DRAWN BY: REH
DESIGN BY: REH
CHK'D BY: REH
DATE: 12/1/98
C2A

I have reviewed the Drainage Plans and inspected the project. I find that the drainage improvements and site construction is in substantial compliance with the plans originally submitted to the City of Albuquerque for construction permit with the noted modifications.

PROJECT TITLE
WESTWOOD APARTMENTS
MARKET STREET ALBUQUERQUE, NEW MEXICO
SHEET TITLE
GRADING AND DRAINAGE PLAN

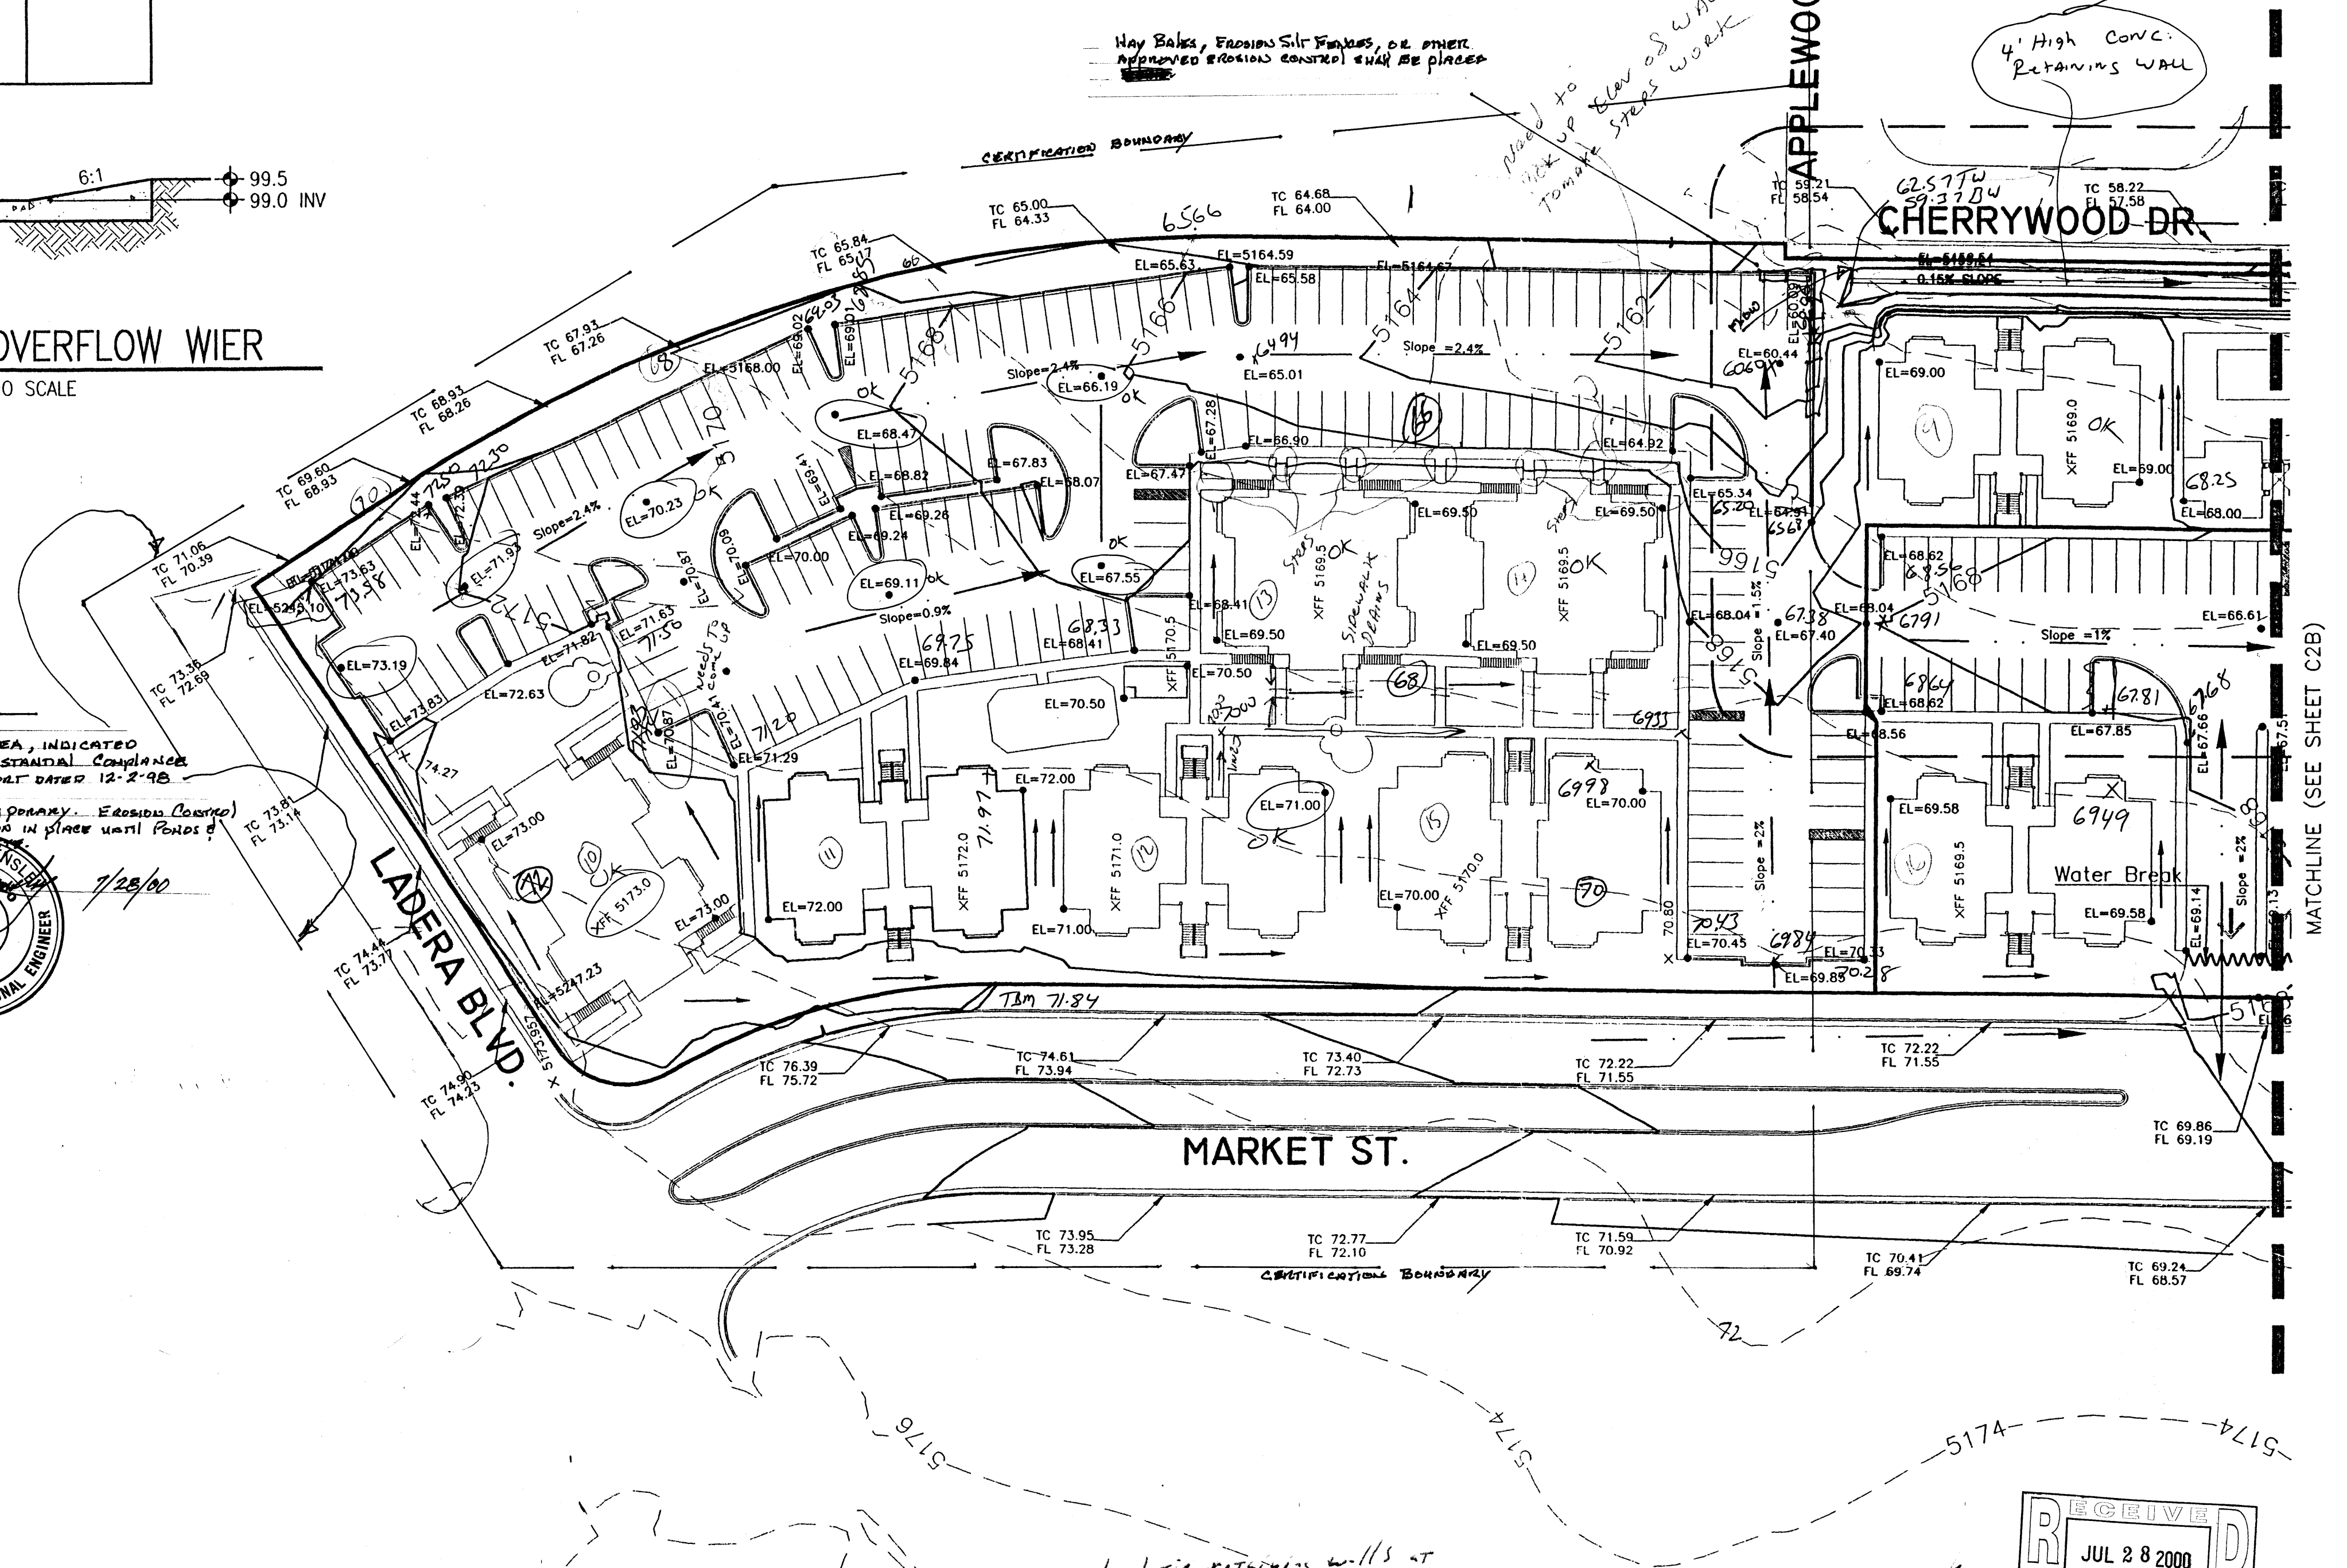
NOTE: SWALE & RETAINING WALL MODIFICATIONS ARE NOT CERTIFIED, & WILL REQUIRE DRAINAGE PLAN AMENDMENT.

Delete railroad tie retaining walls at station and station walls and replace with erosion control blanket and temporary for active grade per bond of Exhibit 1

DRAWN BY
REH
DESIGN BY
REH
CHK'D BY
REH
DATE:
12/1/98
C2A

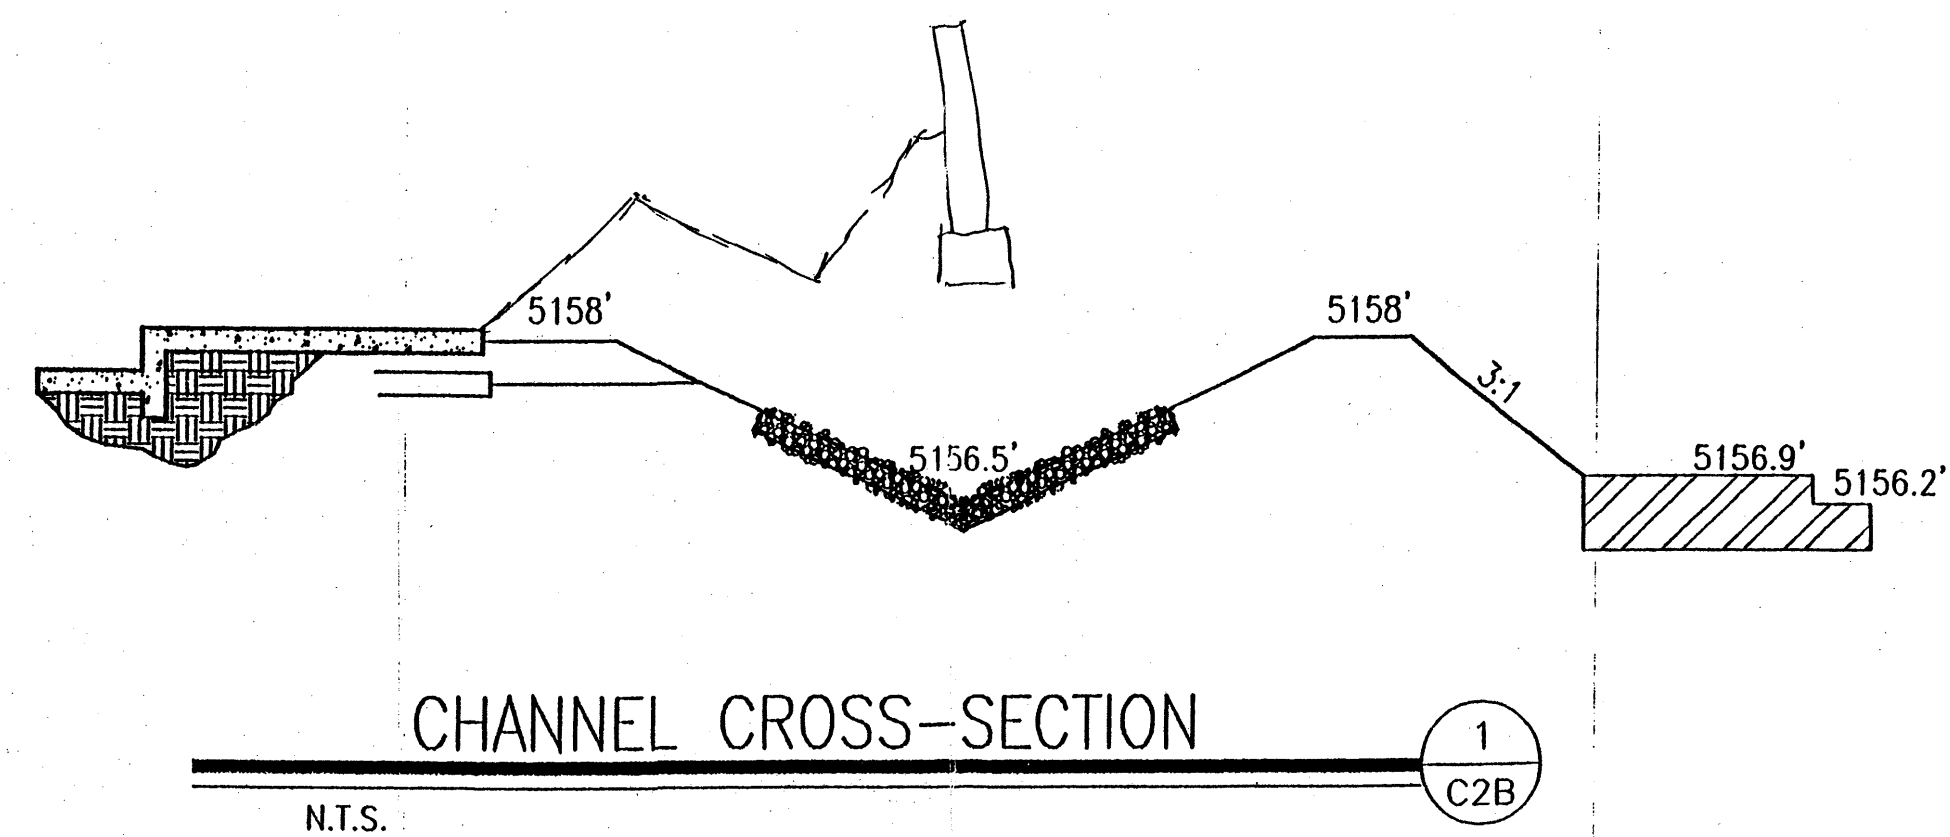
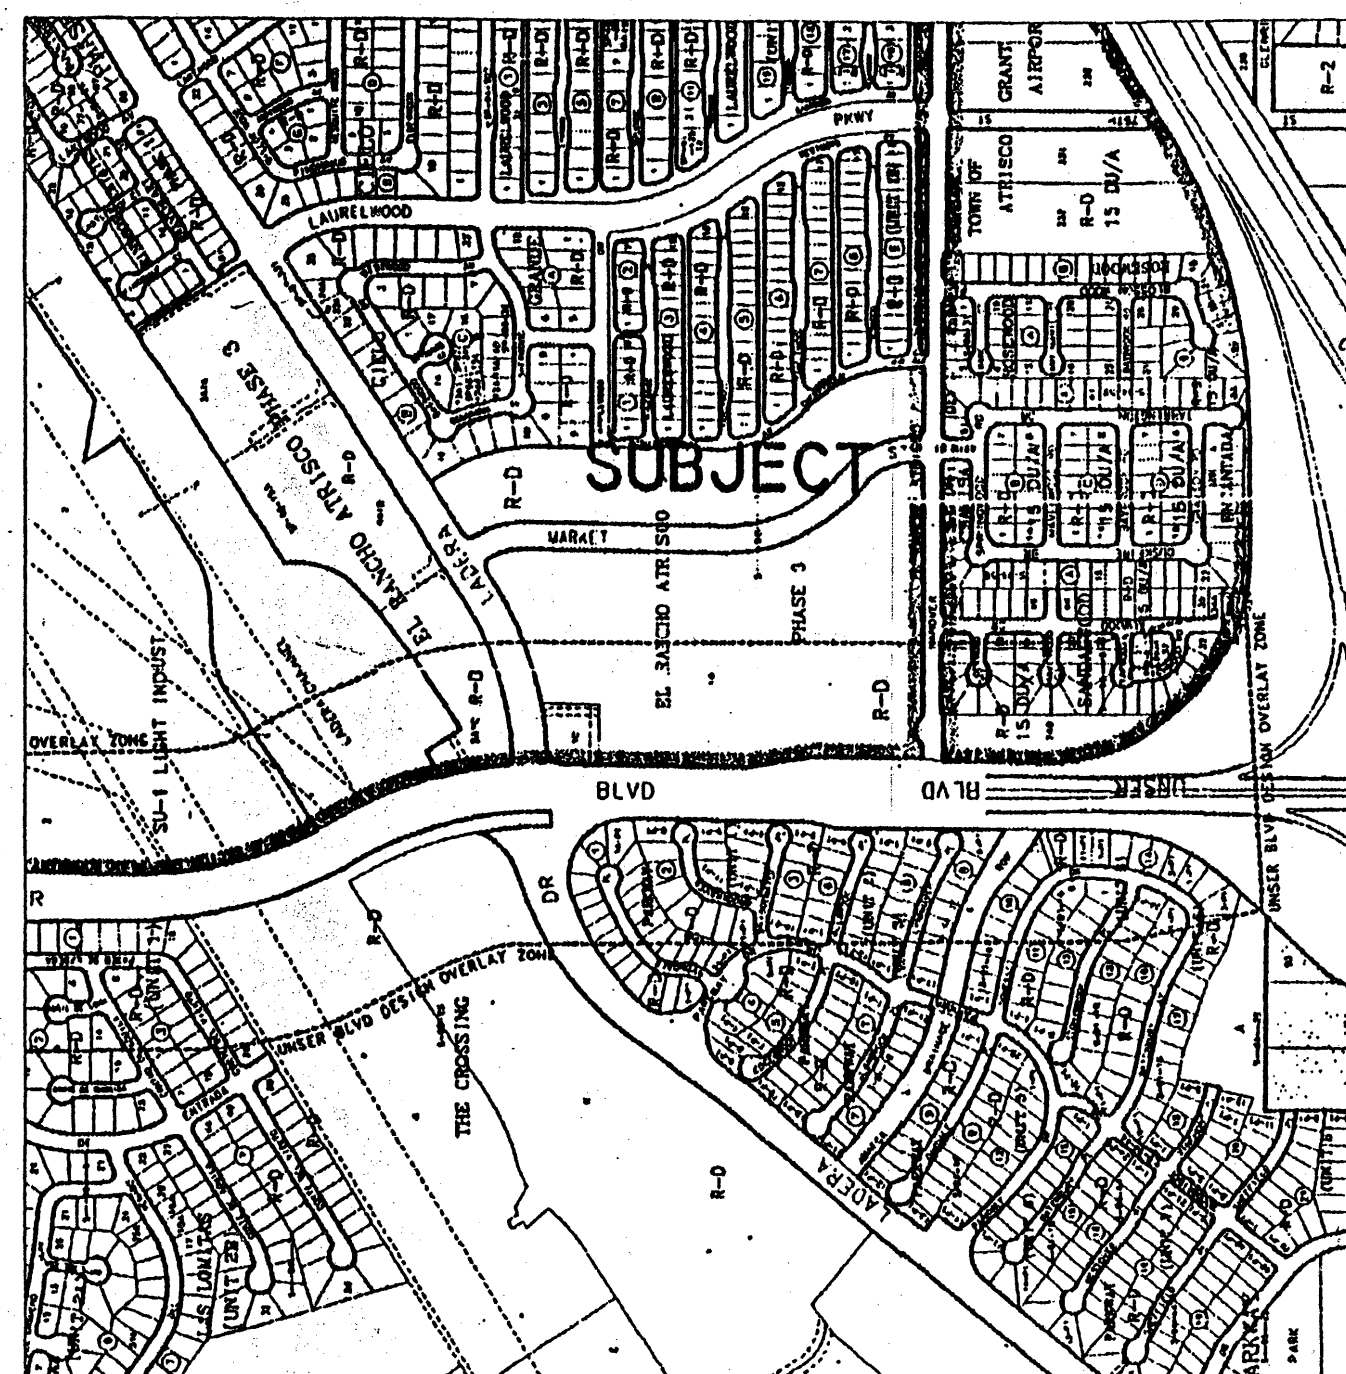
Delete railroad tie retaining walls at 7' elevation and 2' from walls and replace with erosion control blanket and top vegetation. For native grass per 6-0 of Exhibit 1.
